STATION HILL

READING

AMENDMENTS TO RMA REF
190466 PLOT F

NOV 2019

Plot F - Lower Ground Floor Level (39 AOD)

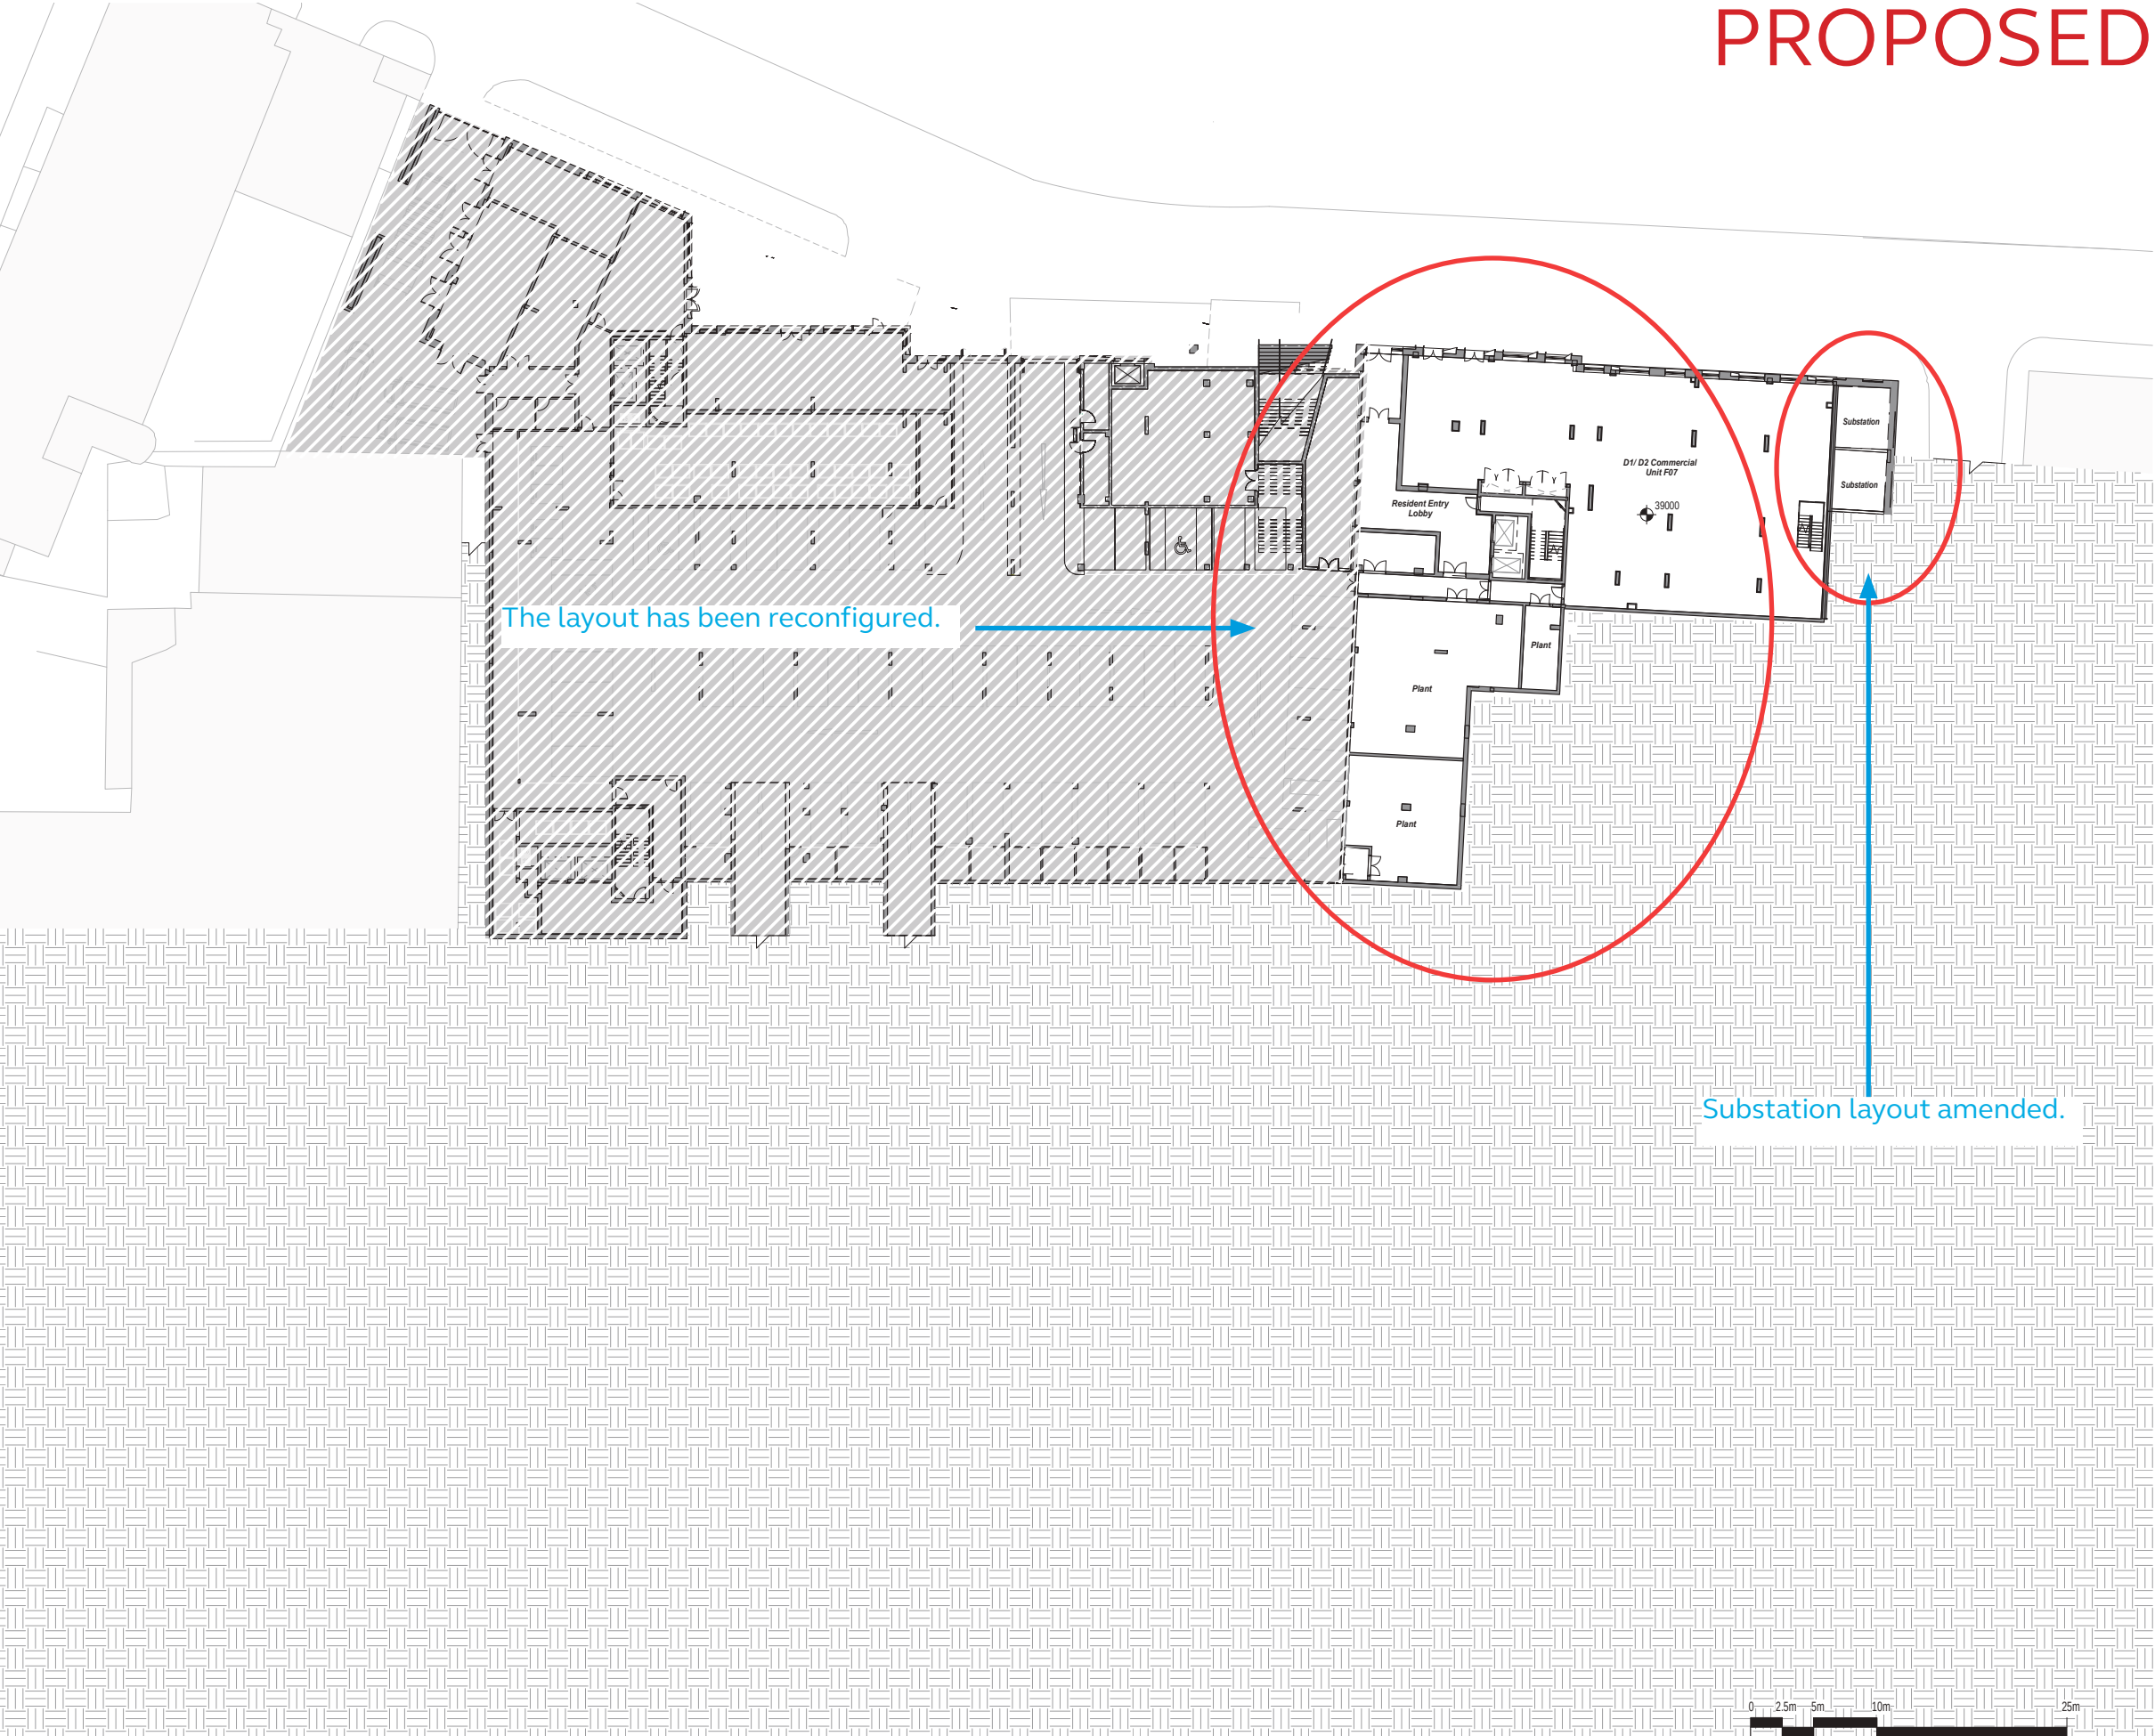
The layout has been reconfigured.

Substation layout amended.

SHEET IDENTIFICATION
TITLE
Plot F - Floor Levels 01-04

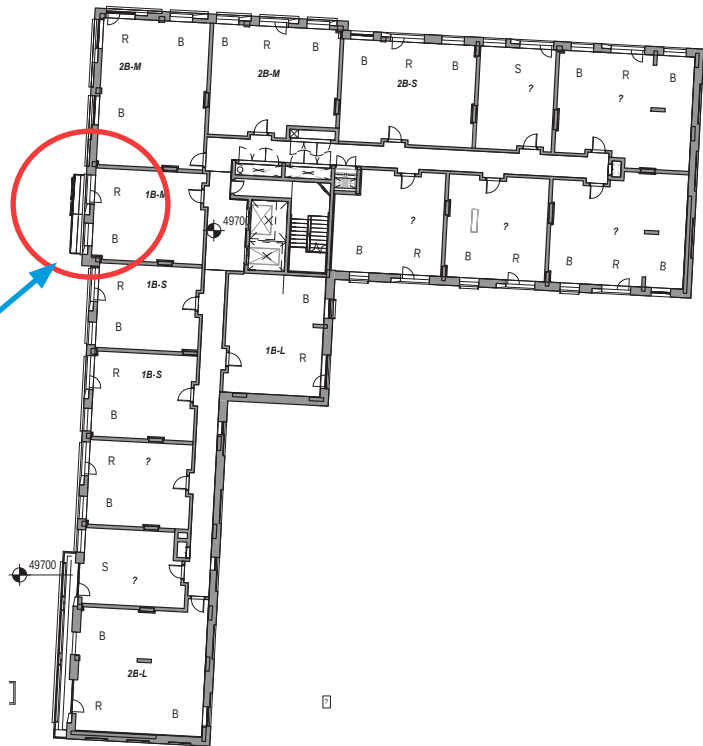
2no. canopies merged into one above the reconfigured entrance. Canopy size adjusted to 5.6 m x 0.9 m.

SHEET IDENTIFICATION
TITLE
Plot F - Garrard St - Bay Elevation

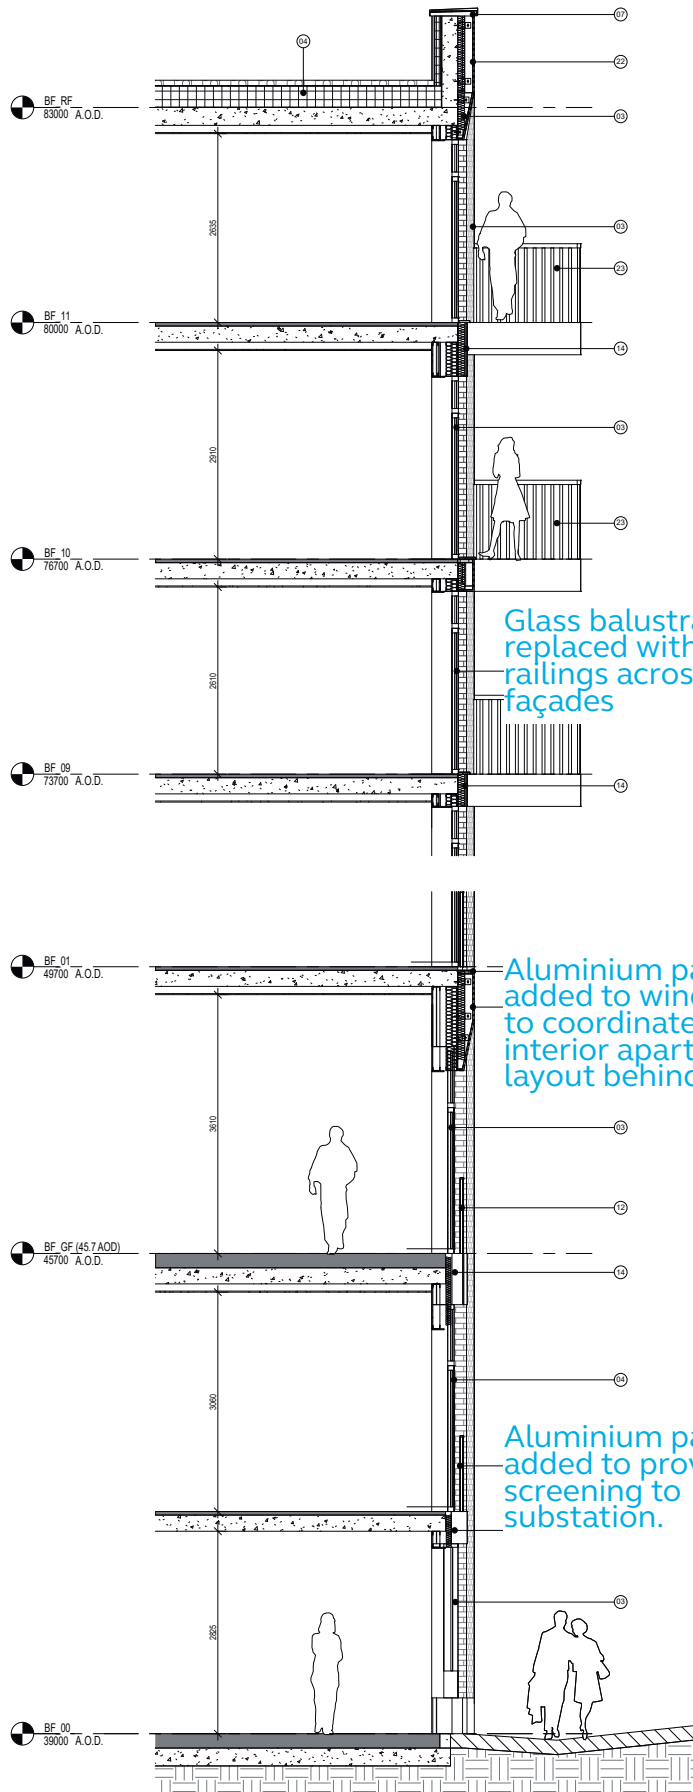
Aluminium panel added to window to coordinate with substation wall behind.

1 Site - Friars Walk West Elevation Plot F
1 : 250

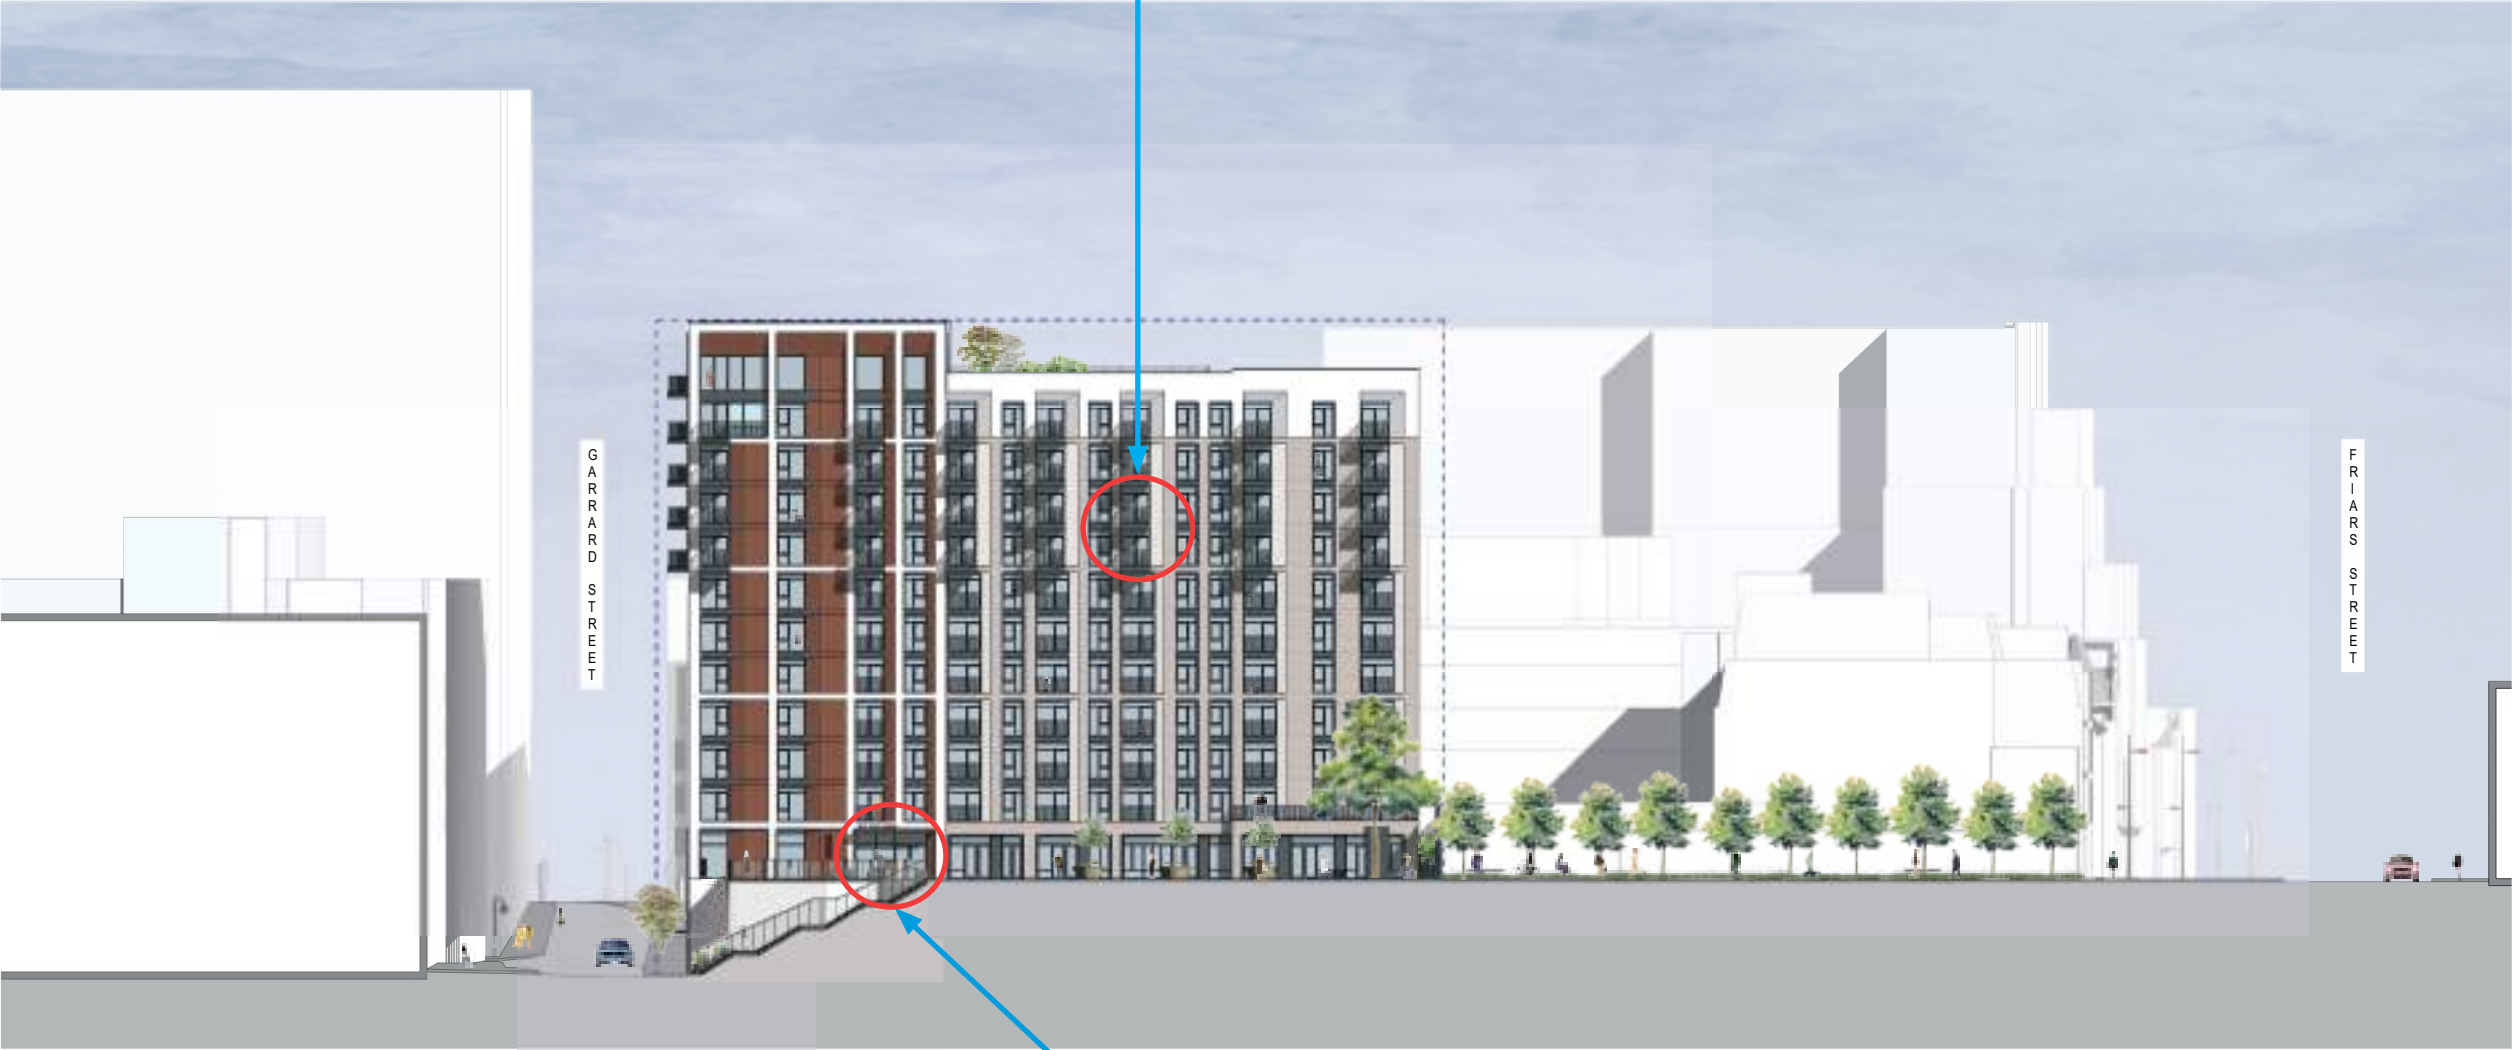
Glass balustrades replaced with metal railings across all façades

Entrance to Plot F moved along and canopy above adjusted to suit new entrance location.

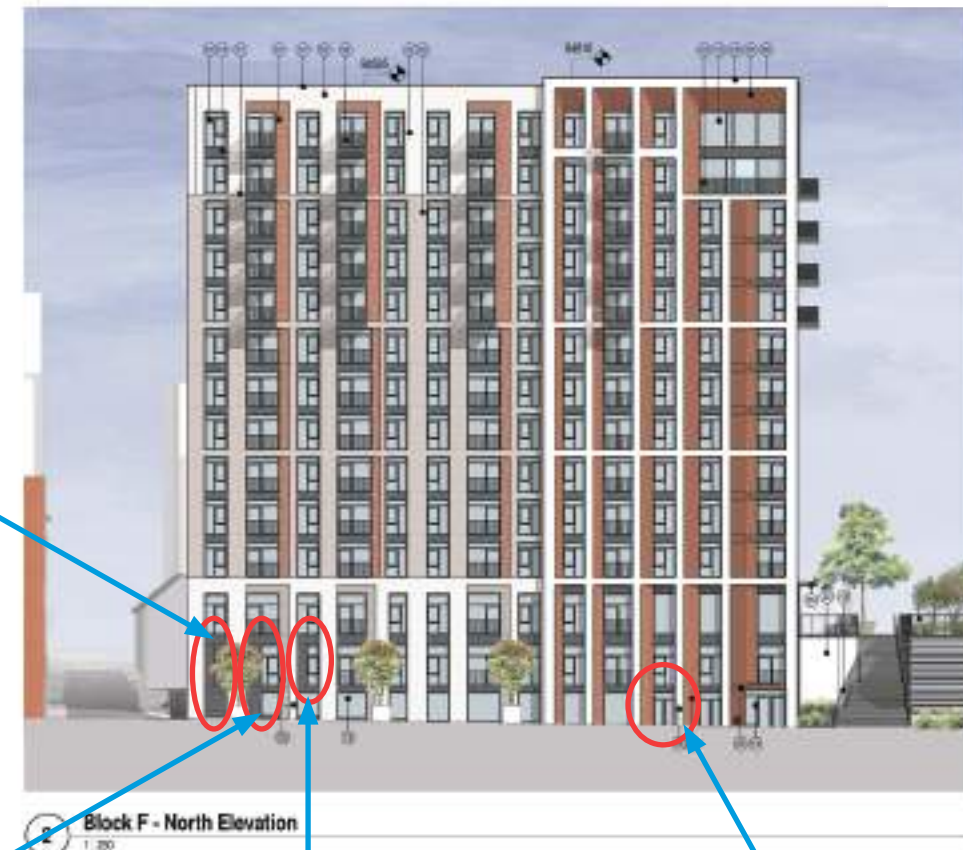
Cladding setting out adjusted to internal layouts.

Glass balustrades replaced with metal railings across all façades

Aluminium panel added to provide screening to substation.

Aluminium panel added to window to coordinate with substation wall behind.

Aluminium panel added to window to coordinate with interior apartment layout behind.

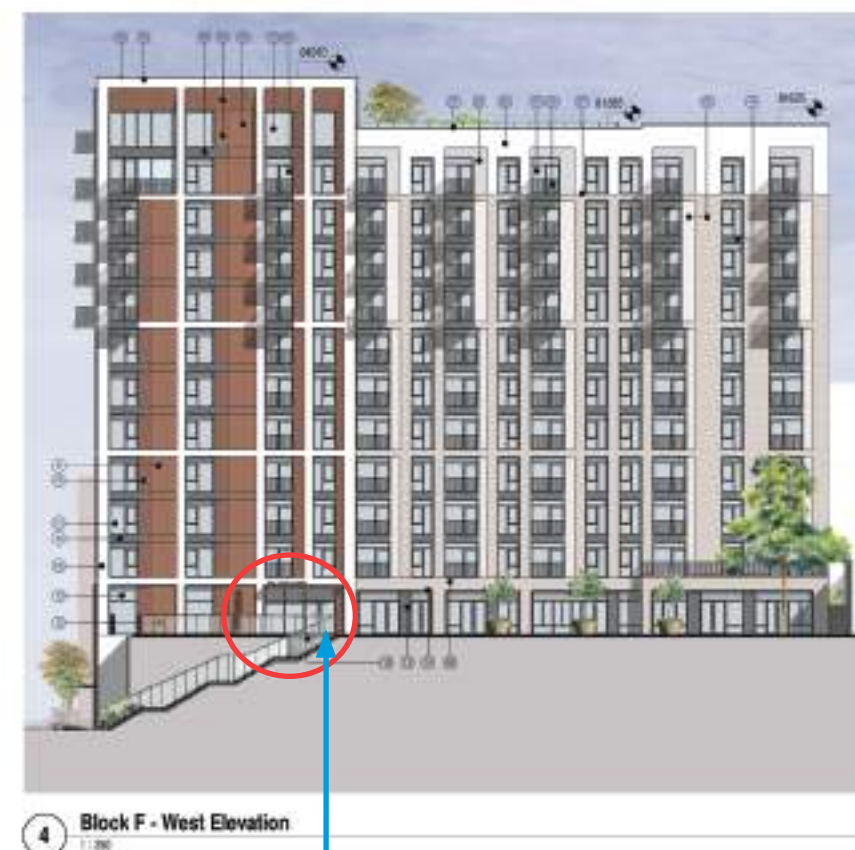
Additional escape door added to D2 unit.

Entrance to Plot F moved along and canopy above adjusted to suit new entrance location.
